II. Drawings

^ Appln. No. 10/766,384

Attorney Docket No. 10541-1824 Visteon Disclosure No. V203-0076

Fig. 1

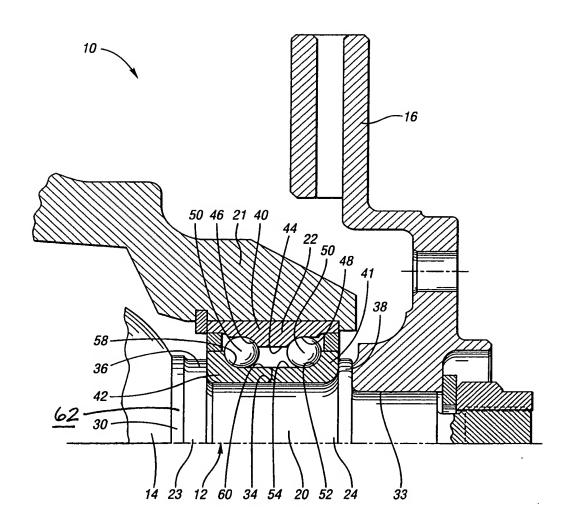
Responsive to the objection to the drawings under 37 CFR 1.83(a) that "the detachable half shaft assembly being detached from the shaft bell" be shown, Applicants have proposed an amendment to the drawings. For clarification purposes, the dashed line underlying the shaft bell 14 has been amended to a solid line to more clearly distinguish between the detachable half shaft assembly 12 and the shaft bell 14. As amended, the drawing shows that the detachable half shaft assembly and the shaft bell are not integral elements, but rather separate components analogous to the relationship between the detachable half shaft assembly 12 and the disc rotor 16.

Responsive to the rejections of claims 1-6 and 9-15 under 35 U.S.C. § 112, second paragraph, Applicants have proposed an amendment to the drawings for clarification purposes to more clearly show that the shaft bell 14 and the detachable half shaft assembly 12 are not integral elements. Further, it is well known in the art that the shaft bell is connected to the front or rear axle of the vehicle and provides support to the whole assembly. By the drawings, it is illustrated that shaft bell 14 engages detachable body 20 (at inboard interface 30) to which disc rotor 16 connects (at outboard interface 33). Moreover, the specification clearly mentions that the detachable half shaft assembly 12 is detachable from the shaft bell 14 or the disc rotor 16. "The detachable half shaft assembly 12 is detached from the shaft bell 14 or the disc rotor 16." Specification, paragraph [0018] (emphasis added); see also claims 1 and 9 as filed. Therefore, it is shown that analogous to disc rotor 16, shaft bell 14 is a distinct element from the detachable half shaft assembly 12.

Rig. 3

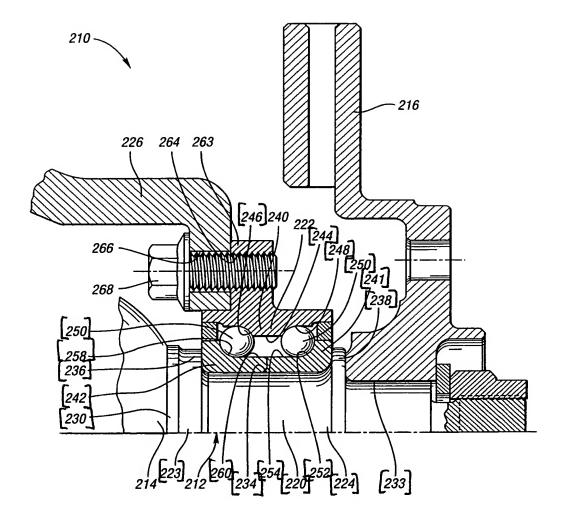
Responsive to the objection to the drawings under 37 CFR 1.84(p)(5) because they included characters not mentioned in the description, Applicants have proposed an amendment to the drawings to remove reference numerals not mentioned in the description. More specifically, reference numerals 144, 148, 150, 158, 160, 134, 154, 152, and 133 have been removed from Figure 2 and reference numerals 241, 242, 246, 244, 248, 250, 238, 233, 224, 252, 220, 254, 234, 260, 223,

230, 236, and 258 have been removed from Figure 3. Reference numeral 123, however, has not been removed from Figure 2 because paragraph [0021] of the specification makes reference to reference numeral 123.
